KINGSTON STEAM PLANT
 ASH DISPOSAL AREA DIKES RAISING
 SOILS INVESTIGATION REPORT
 DATED 11/3/75 AND EVALUATION OF REPORT
 (CDB RECORD COPY)

Kingston Steam Plant - Ash Disposal Area Dikes

Raising - Soils Investigation Report 11/3/75 and
Evaluation

Kingsport Steam Plant - Ash Disposal Area Dike Raising -
Soils Report 11/2/75 - Evaluation

KINGSTON STEAM PLANT
FOUNDATION INVESTIGATION
BORINGS 1-8

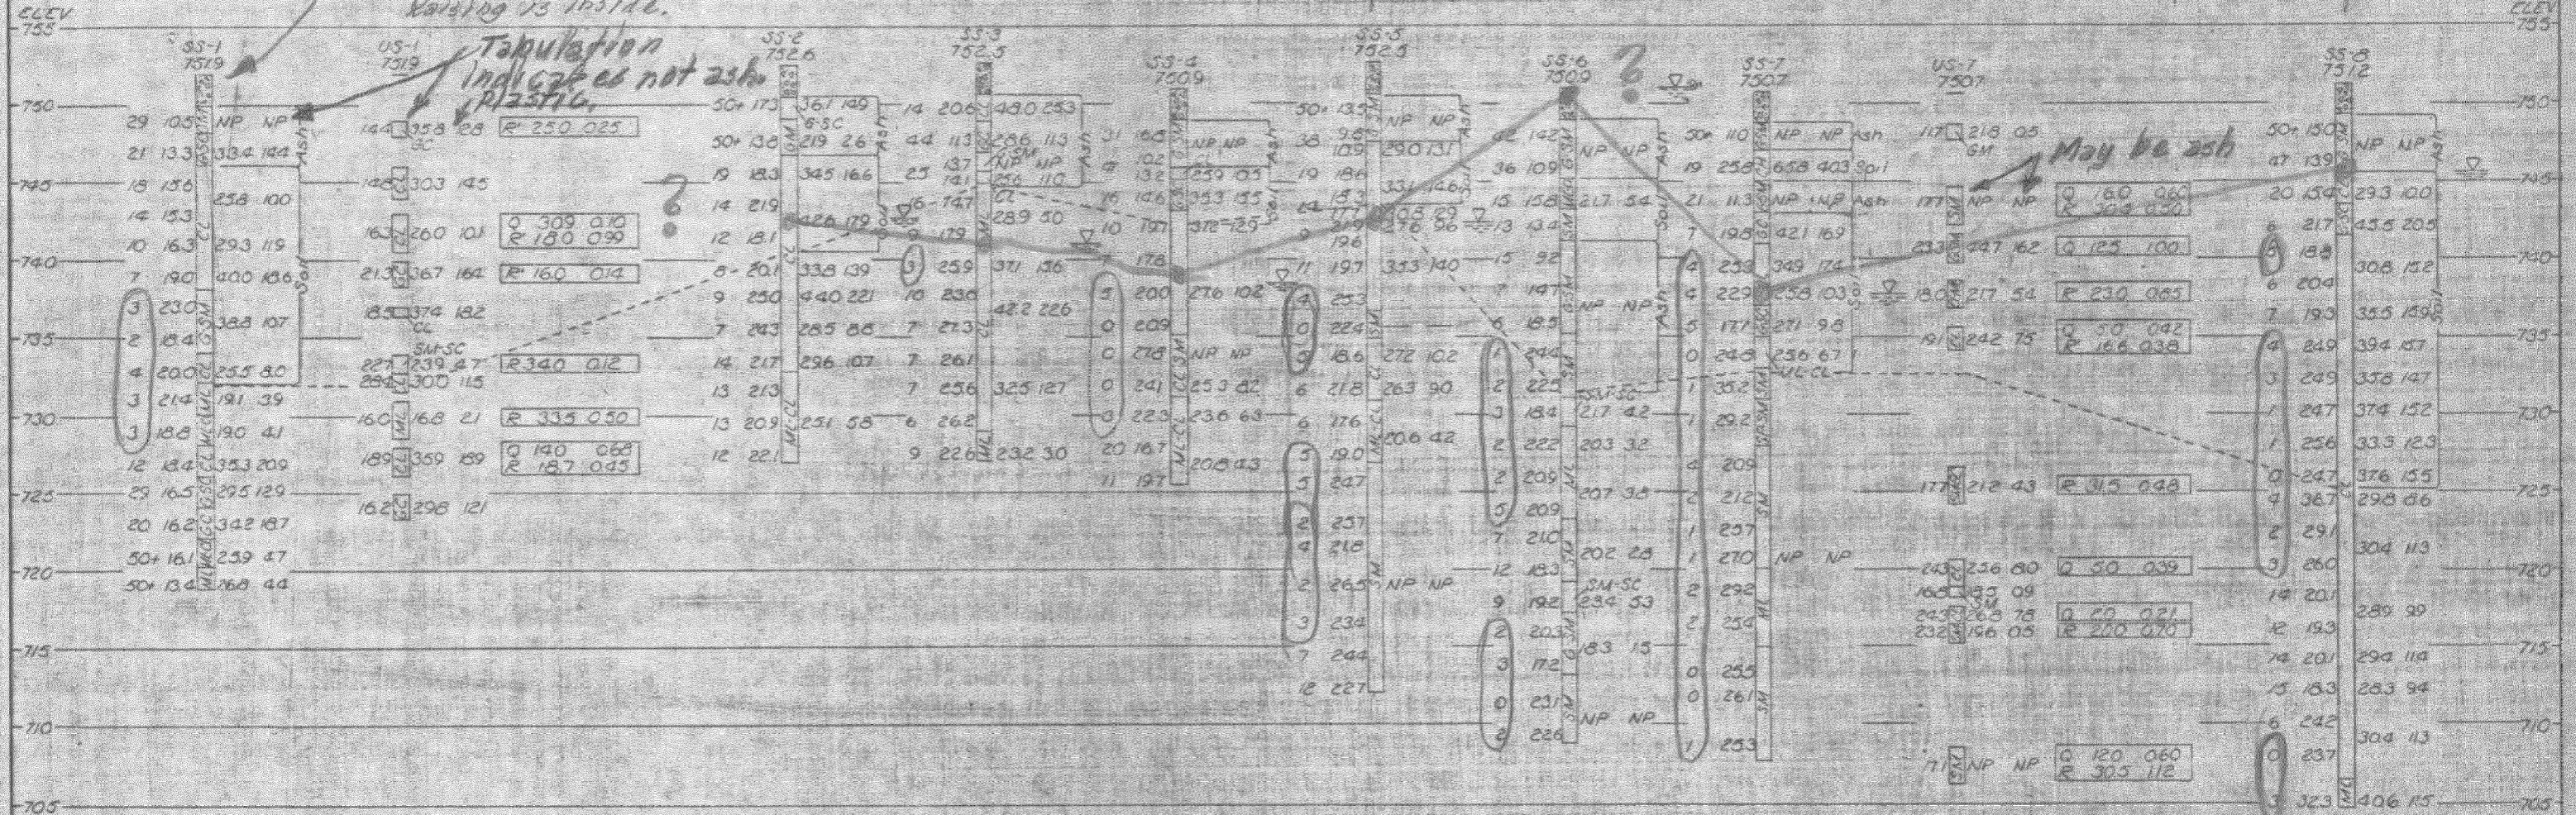
With waste fill of shale & limestone, to be removed. Don't need to remove on old dike. Raising is inside.

Blows 1000 lbs. This was supposed to have dike all of ash. It does not.

Tabulation indicates not ash.

May be ash

Borings 1-8 are Old DIKE C

KINGSTON STEAM PLANT
 FOUNDATION INVESTIGATION
 BORINGS 9-16

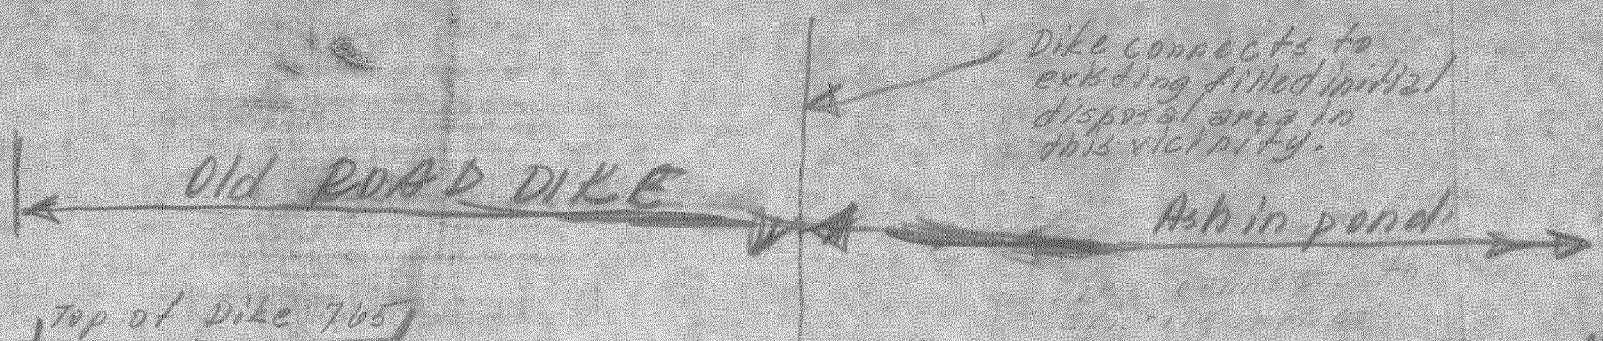
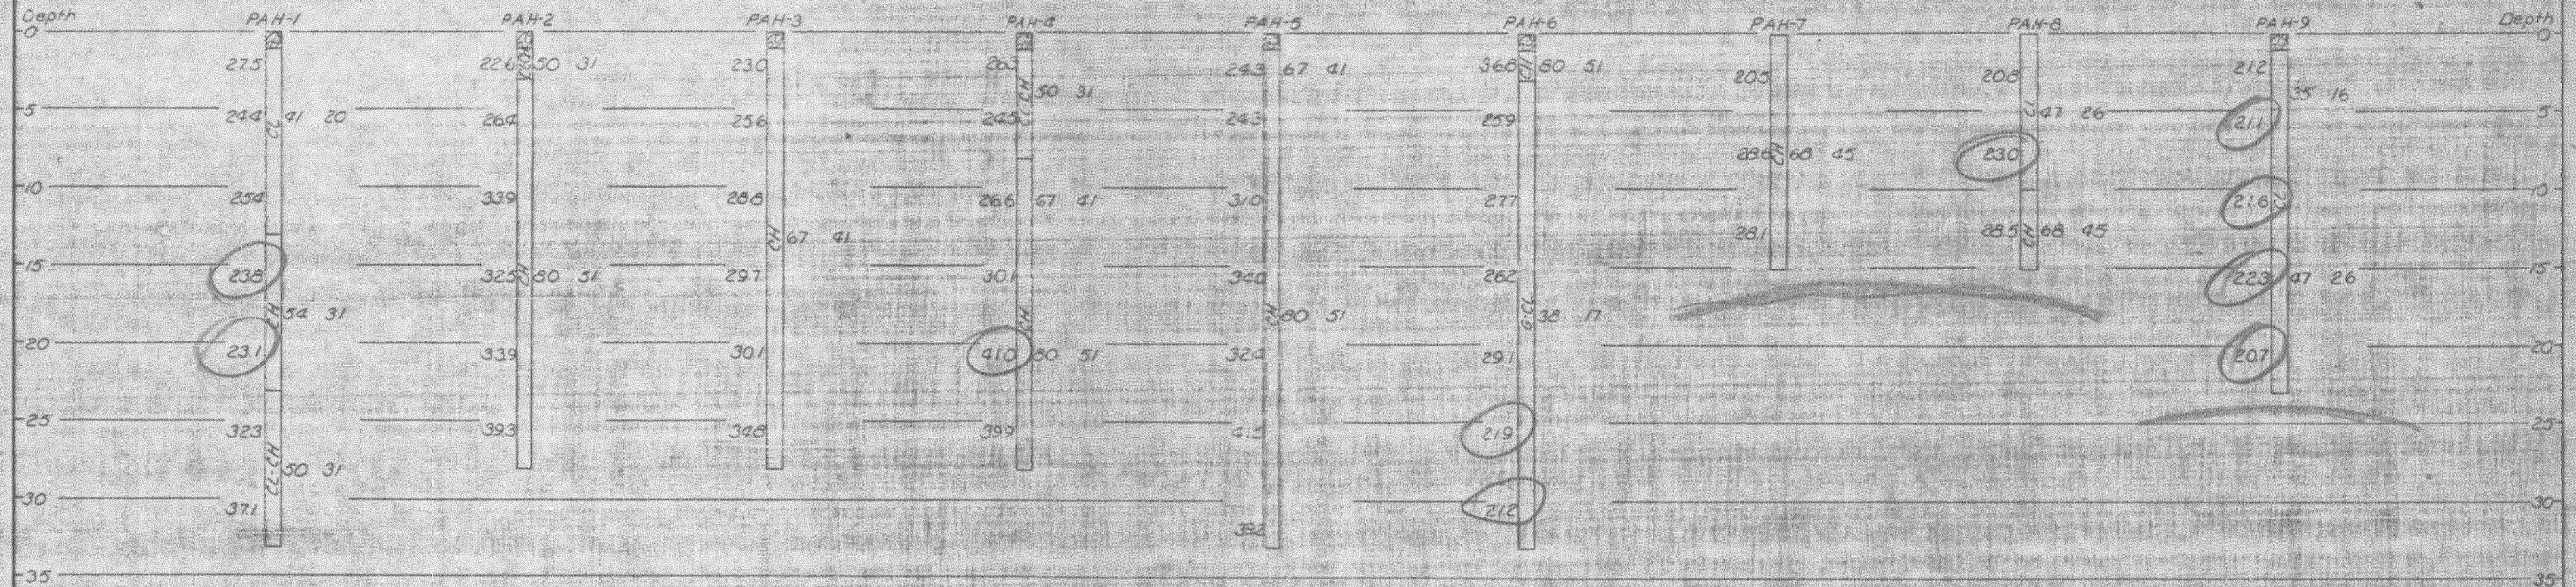
Pond water is El 746±
 Water in this higher ash is
 at top of ash. Does not drain.

Ash symbolized by "M" etc.
 Its all ash

Borings not as deep as others. Strange.
 Adjacent boring 8 was all soil, no ash.
 Ground line? Green marks are upper top.
 Holes 9, 10, since symbols say clay, it
 is not ash which is symbol of M, S, etc.

The overlying ash has not consolidated the finer lower ash.

This is the "dry haul"
 disposal area inside
 of old NORTH DIKE.

SCALE 1"=10'			
KINGSTON STEAM PLANT			
BORROW INVESTIGATION AREA A			
BORINGS 1-9			
TENNESSEE VALLEY AUTHORITY			
MATERIALS ENGINEERING LABORATORY			
DATE	REVISION	BY	APP'D
10/75	36	ES	J
MEMPHIS	60460760

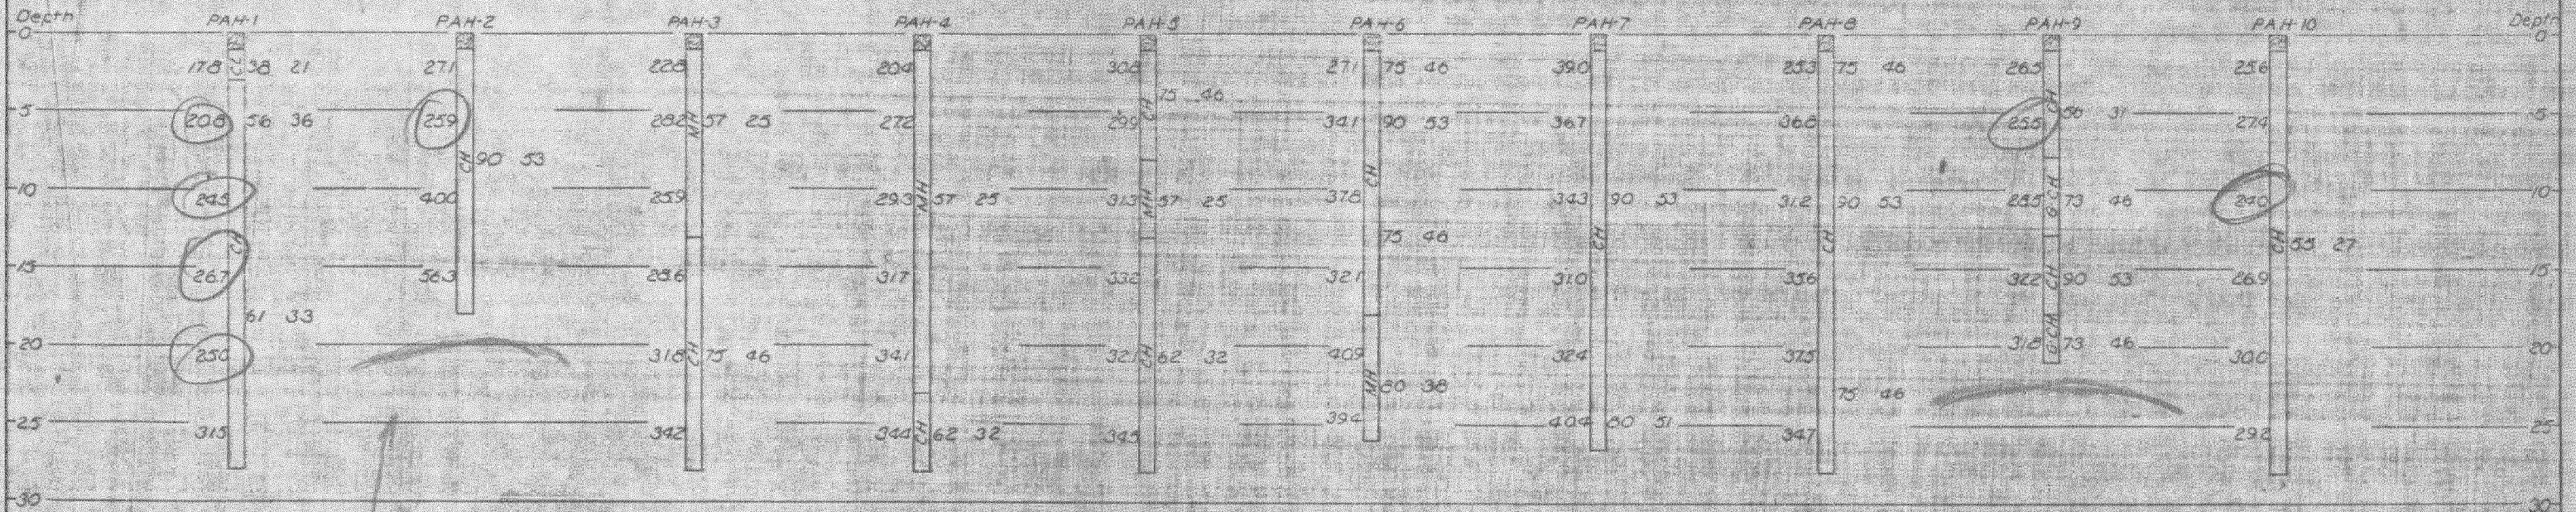
Plot is depth.
 No indication of topo re high and low areas
 effect on moisture. CL+CH so probably little effect anyway.

Area A is apparently somewhat less CH, and somewhat drier, than Areas B+C.

Classes III + IV CH
 Opt moisture 25 to 30.
 Classes I + II CL + sandy CH
 Opt moisture 20 to 22.

Indications also: Area A 15' plus to wet borrow.
 Area B 20' " " " " "
 Area C, partly 10' " " " "

No obvious stratification.
 Moisture contents fairly consistent.
 Apparently generally drier than Areas B+C.

Groundwater in borrow areas?

Phone with lab (Childres) 11/11/75
 Effort was not made to locate groundwater as such.
 The "high borings" were terminated when soil became obviously wet.

KINGSTON STEAM PLANT
BORROW INVESTIGATION
AREA B

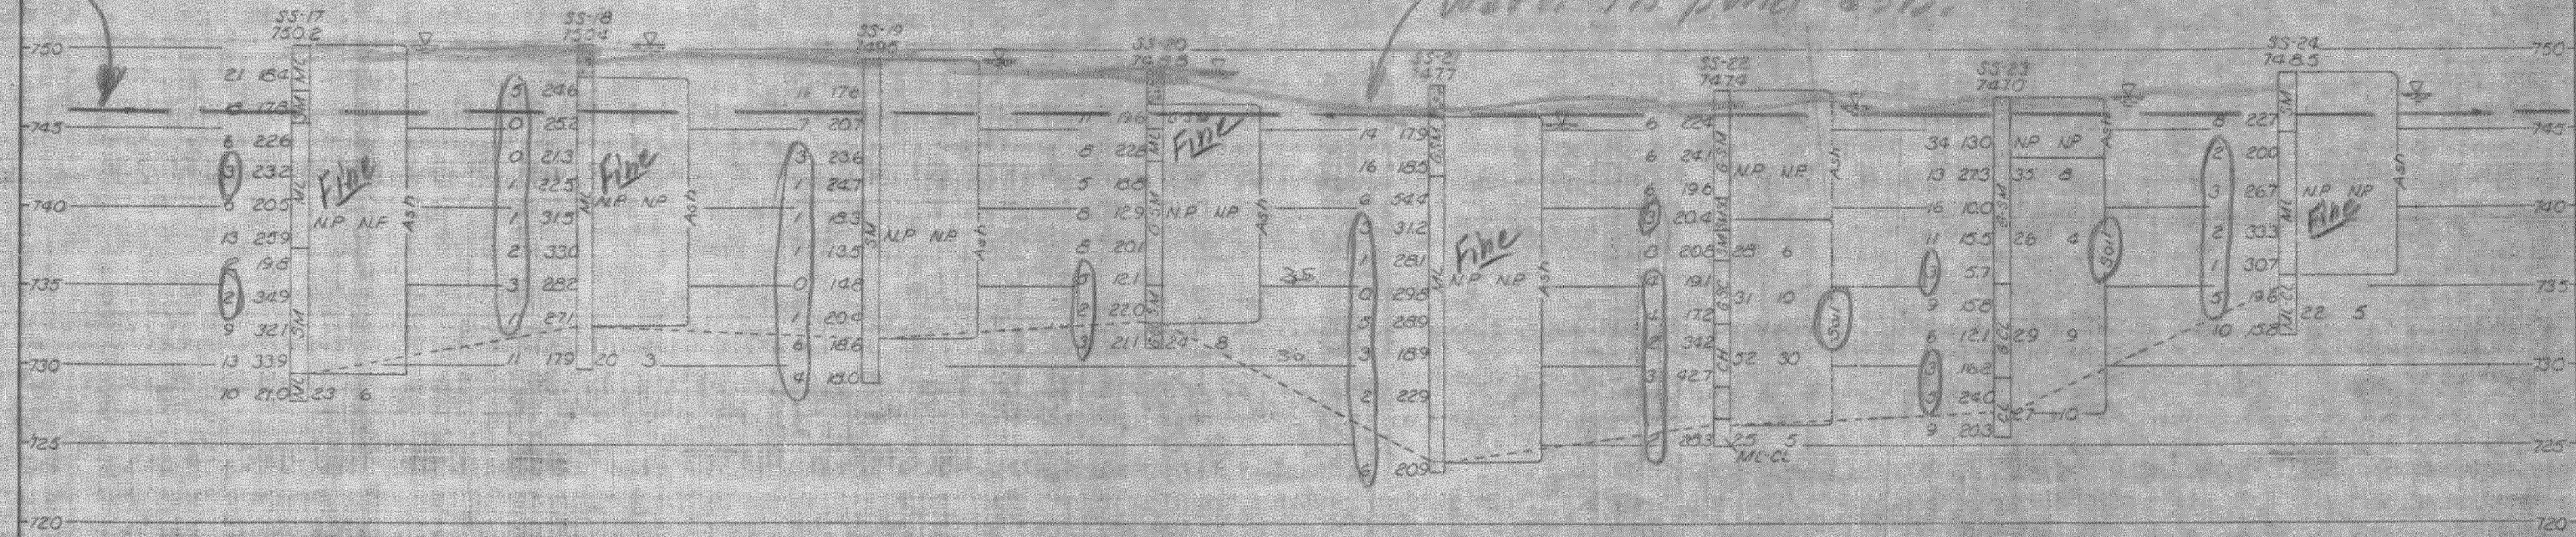
Groundwater?
See dug 607.

No obvious stratification.
Mostly highly plastic CH
Moisture contents fairly consistent

Area A is less CH
Area C is all CH and
moisture variable.

KINGSTON STEAM PLANT
FOUNDATION INVESTIGATION
BORINGS 17-24

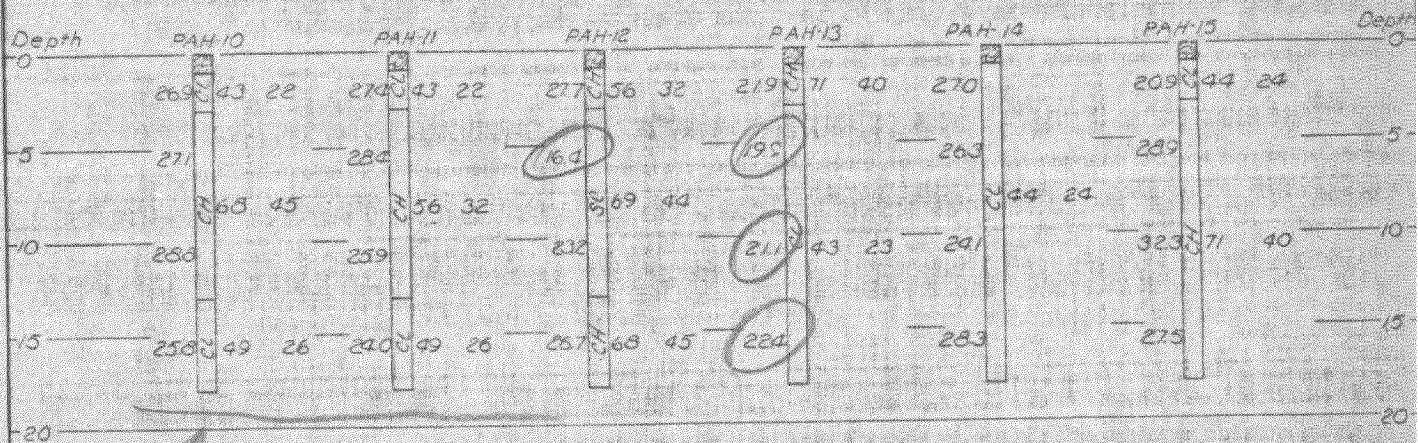
Ash inside
old DIKE C

Ash inside
old ROAD DIKE

Soil Request says borrow ash only above
E 746. There is little. But request says take up for
density and strength in-situ. This was not done.

Water in pond ash.

These are borings
of ash in pond
along old DIKE C
and ROAD DIKE

Not foundations
Ash in pond.
